Well Name: JICARILLA K	Well Location: T23N / R2W / SEC 4 / NWNW /	County or Parish/State: RIO ARRIBA / NM
Well Number: 4	Type of Well: CONVENTIONAL GAS WELL	Allottee or Tribe Name: JICARILLA APACHE
Lease Number: JIC157	Unit or CA Name:	Unit or CA Number:
US Well Number: 3003905178	Well Status: Producing Gas Well	Operator: DJR OPERATING LLC

Notice of Intent

Sundry ID: 2697744

**DJR Operating, LLC  
Plug and Abandonment Procedure  
Jicarilla K 157 4  
API # 30-039-05178  
NW/NW, Unit D, Sec. 4, T23N, R2W  
Rio Arriba County, NM**

**DJR Operating, LLC**  
**Proposed Wellbore Diagram**  
**Jicarilla K 157 4**  
**API # 30-039-05178**  
**NW/NW, Unit D, Sec 4, T23N, R2W**  
**Rio Arriba County, NM**

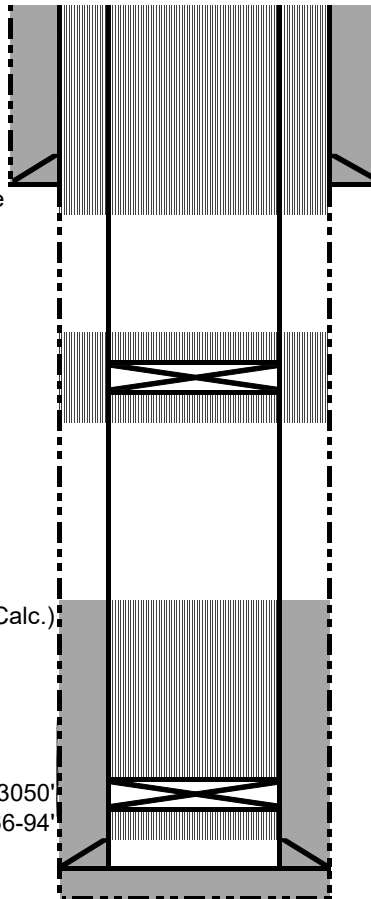
You are also required to place cement excesses per 4.2 and 4.4 of the attached General Requirements.

4.2 All cement plugs placed inside casing shall have sufficient volume to fill a minimum of 100' of the casing, or annular void(s) between casings, plus an excess volume sufficient to provide for 50 linear feet of fill above the plug.

4.4 All cement plugs placed to fill annular void(s) between casing and the formation shall be of sufficient volume to fill a minimum of 100' of the annular space plus 100% excess, calculated using the bit size, or 100' of annular capacity, determined from a caliper log, plus an excess volume sufficient to provide for 50 linear feet of fill above the plug.
